Brookline Preservation Commission

Local Historic District Report

Address: 18 Osborne Road
District: Graffam Mckay LHD
Applicant: Chad & Abigail Cox
Date Built: 1899
Architect: Ralph Jackson
Builder: Charles Collar

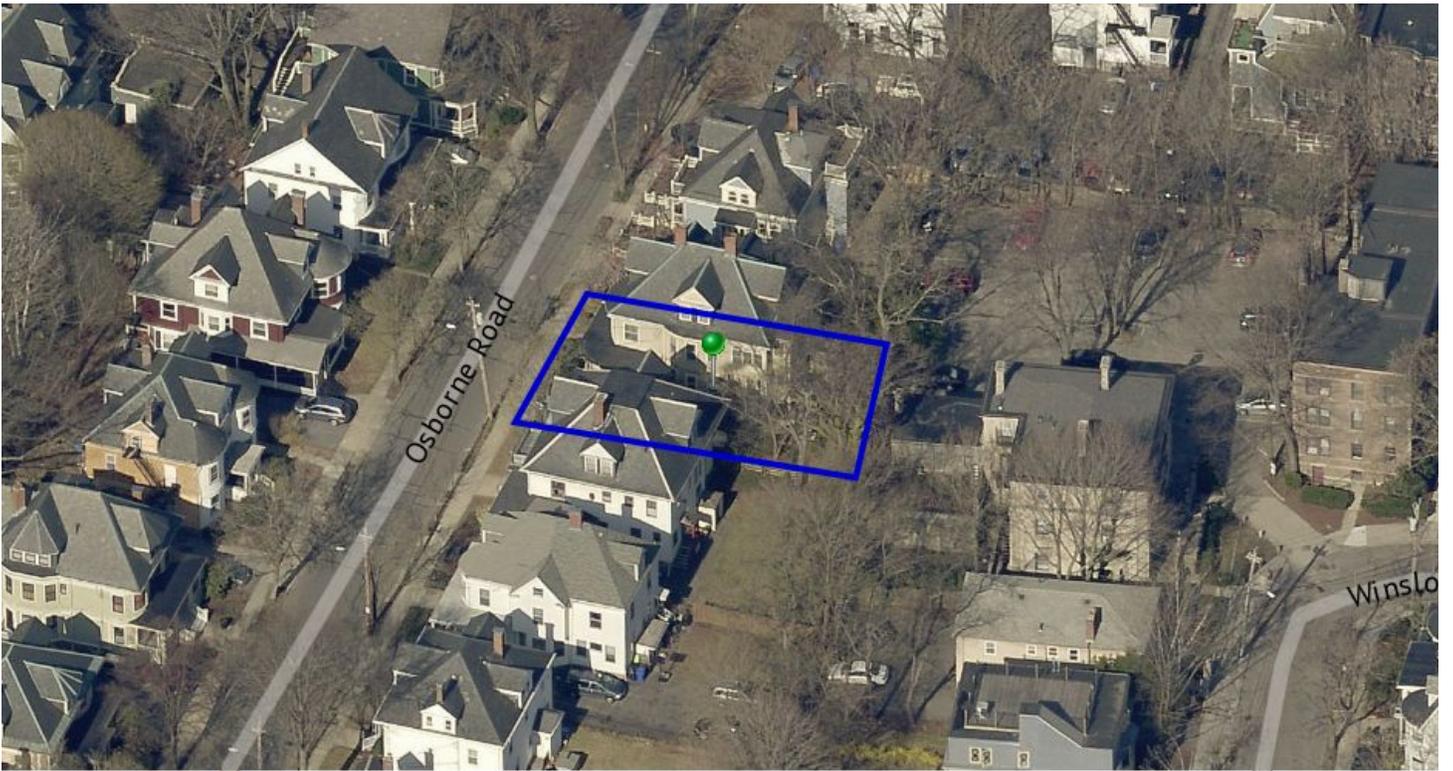
The windows proposed for replacement are not original windows, so the proposal to change the construction from jalousie to one-over-one double hung windows may be appropriate as it is consistent with other windows on the house. The Commission should consider the appropriateness of dividing the left window into two separate sashes as proposed; other one-over-one windows in the house are not arranged in pairs. Since the existing windows are single-glazed, the design guidelines do not support their replacement with insulated glass. Typically, single pane windows are expected to be replaced with single pane. The Commission should also consider the appropriateness of changing the size of the window on the right elevation.
